Proposed Site Elevations

APPLICATION NO: 22/2020/1022/ PF

PROPOSAL: Erection of 2 No. dwellings, construction of a new vehicular access and associated works (Resubmission)

LOCATION: Land Adj to Bryn Teg Gellifor Ruthin

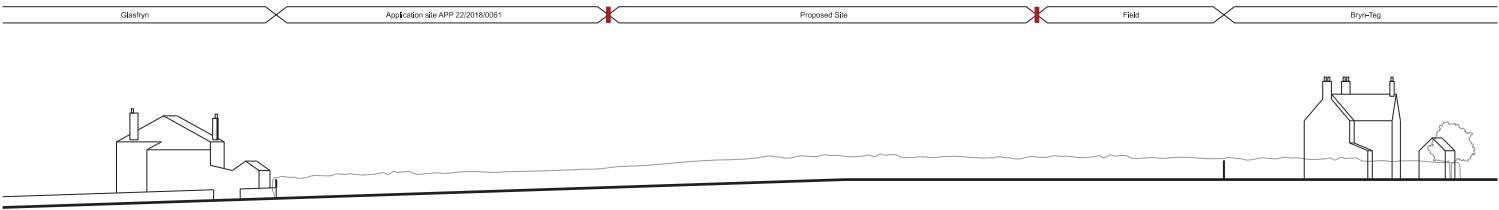
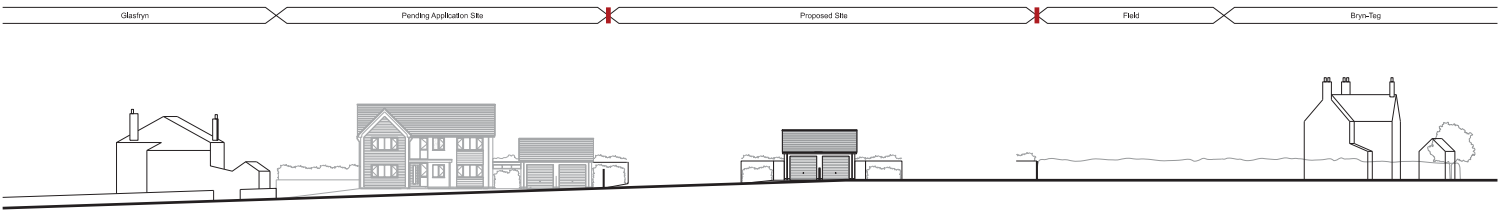
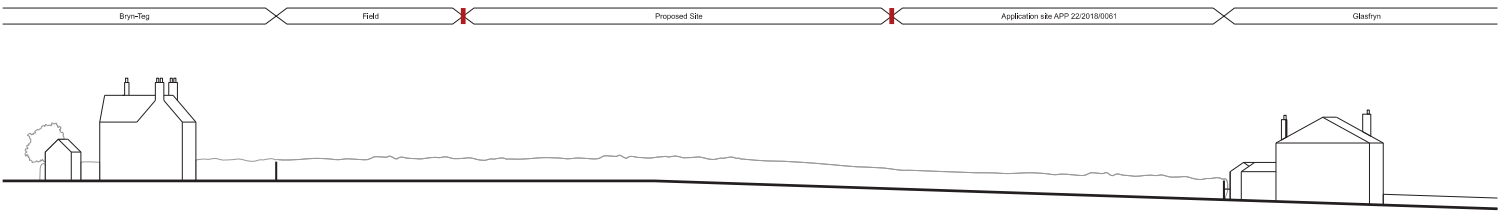
1. That, as notified previously, the road at this location is narrow and in need of widening. As a result, there is concern regarding access and visibility arrangements particularly as the proposed entrance is on a road junction.
2. In addition, there continues to be concern regarding the overall height and size of the proposed dwellings in relation to the site in question.

Objections have been received from the Community Council and members of the public on visual amenity grounds, and have questioned if the height / size of the dwellings proposed is appropriate for the site.

Having regard to the scale, design, form, massing and materials, Officers consider that the amended plans have sufficiently overcome the previous reasons for refusal.

Proposed Site Plan

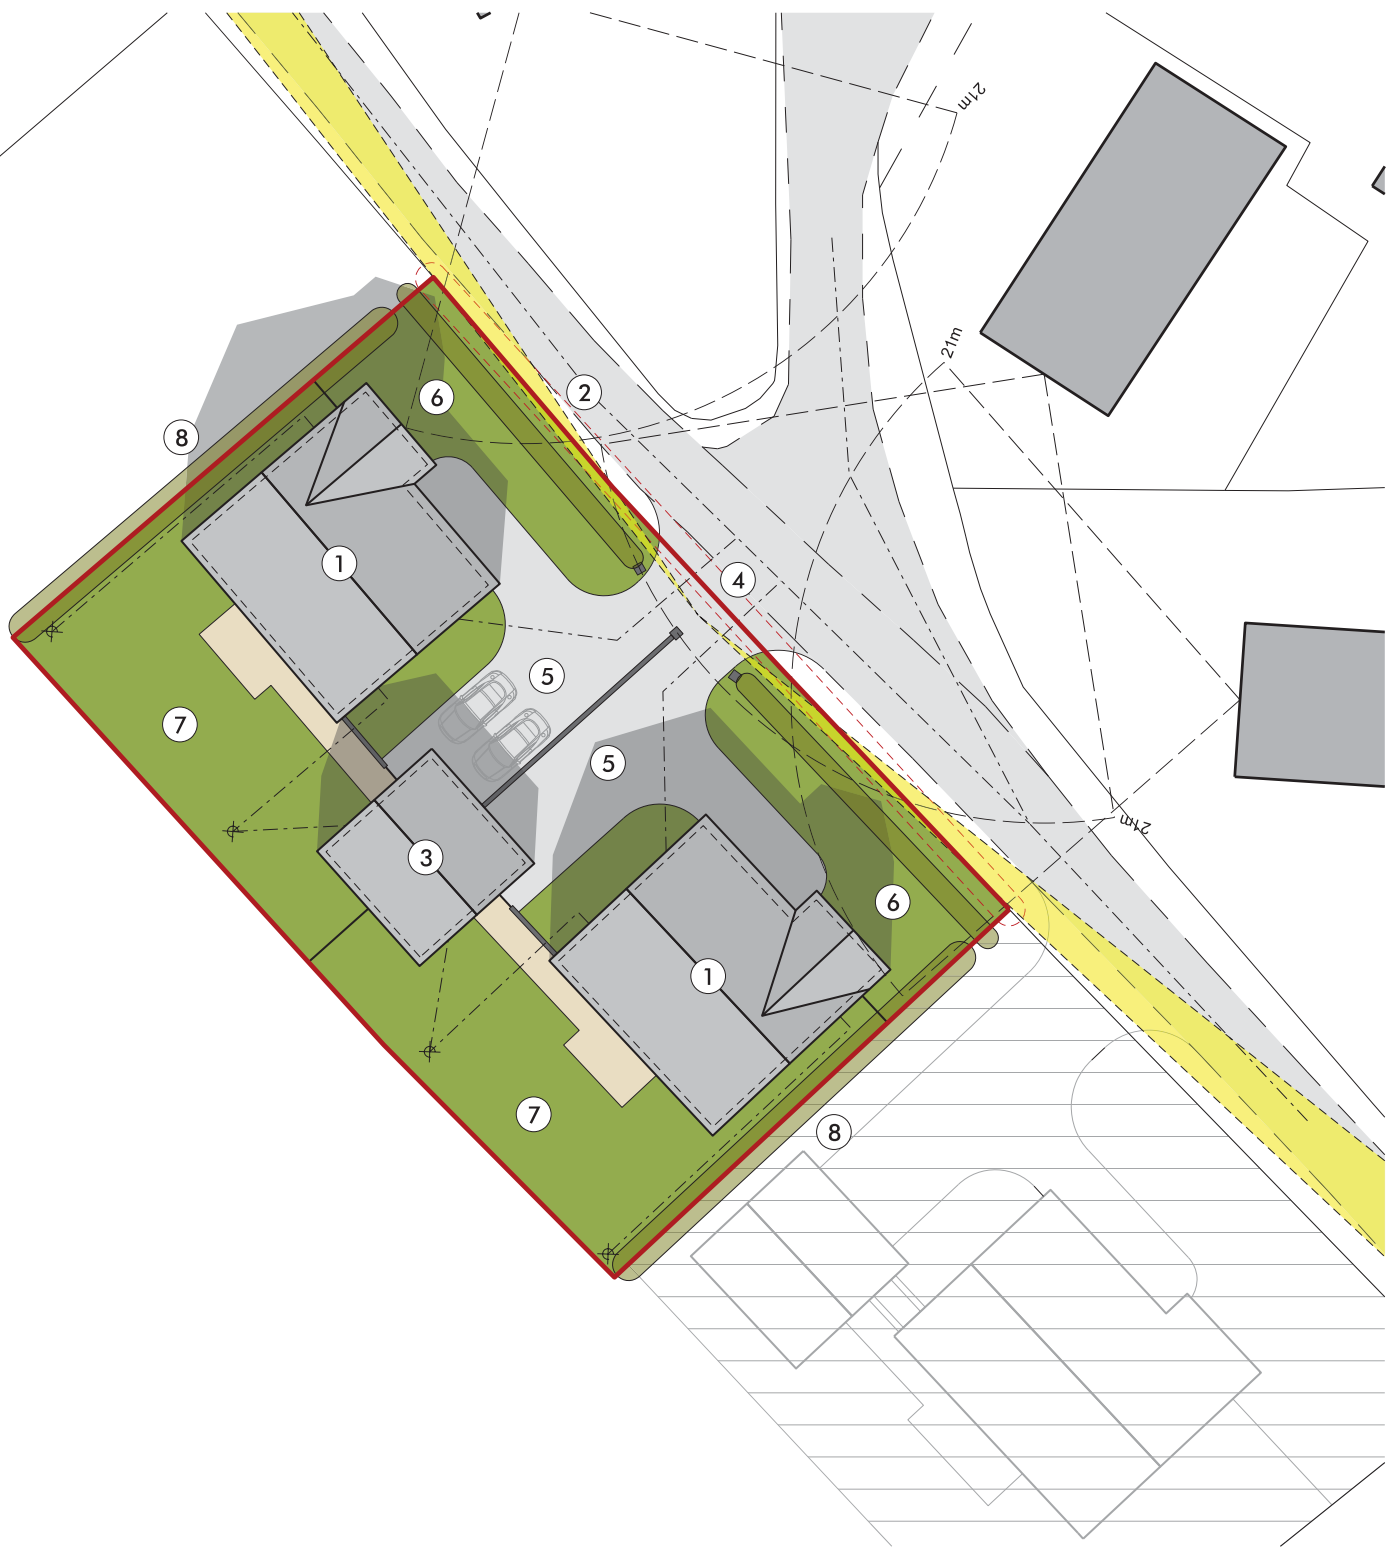
The plans demonstrate that visibility splays of 2.4m x 45m in both directions can be achieved. An independent speed survey has been carried out and the resultant data has been submitted. The visibility splays correspond with the guidelines laid out in TAN 18 Table B.

Having regard to the road speed survey, Highway Officers have confirmed the visibility splays shown on the proposed site plan correspond with the guidelines laid out in TAN 18 Table B.

4. The visibility splays shown on the approved plan shall at all times be kept free of any planting, tree or shrub growth, or any other obstruction in excess of 1.05m metres above the level of the adjoining carriageway.
